BOARD/COMMISSION: Nickel Plate Review Committee

Nickel Plate Review Committee Staff Report

NPR-24-4

REQUEST: Request to approve site design and architecture for the 3,143 square foot residential development.

Proposed Site Plan

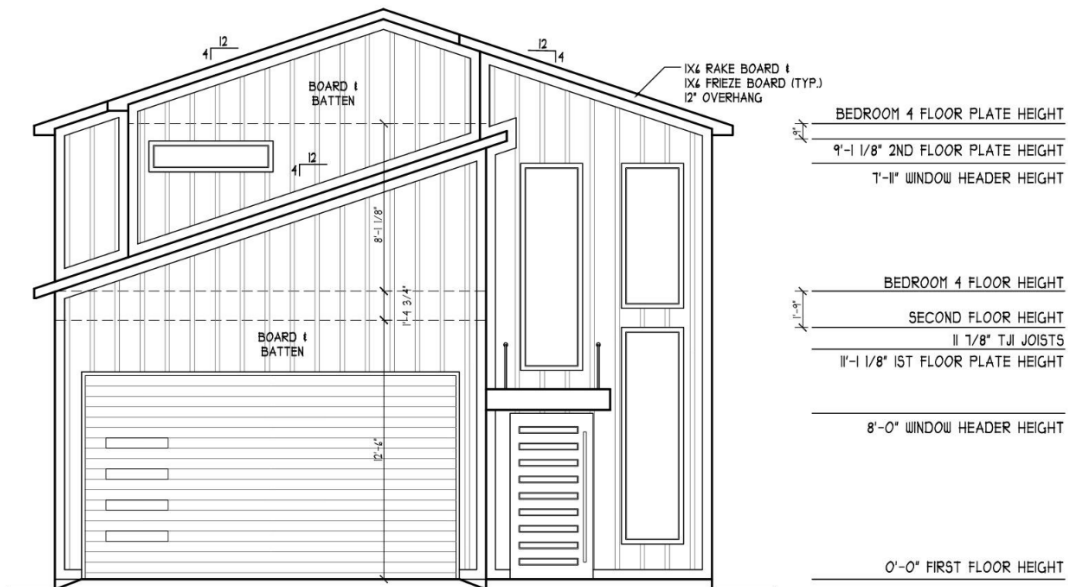
✓ Site access: The proposed vehicular access will be provided off Meadows Drive with a two-car driveway and adjacent garage.

Pedestrian access is also provided off Meadows Drive, sidewalk improvements will be constructed along Meadows Drive.

✓ Parking and vehicle circulation: The proposed home includes a two-car garage and an additional two-car driveway.

✓ Landscape: Proposed landscaping meets the requirements of the Nickel Plate District Code.

Front Elevation (East)

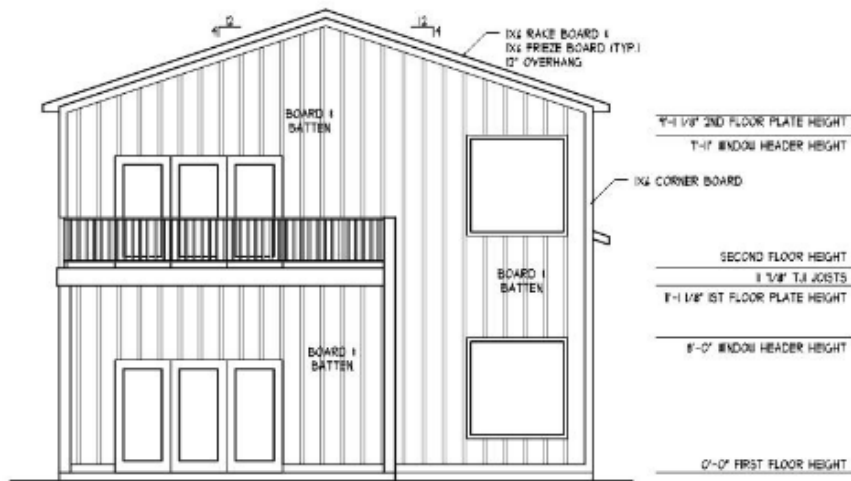
✓ Façade Articulation: Façade articulation and multiple material are provided along the south, east, north, and east of the buildings.

✓ Four-sided architecture: four-sided architecture is provided with two plus building

✓ Roof: The proposed design incorporates multiple roof planes and articulation. The roof style is consistent with the characteristic of the surrounding area.

✓ The building includes a defined base, middle, and top: building has a defined base with prominent entries. The varied roof planes provide a defined top.
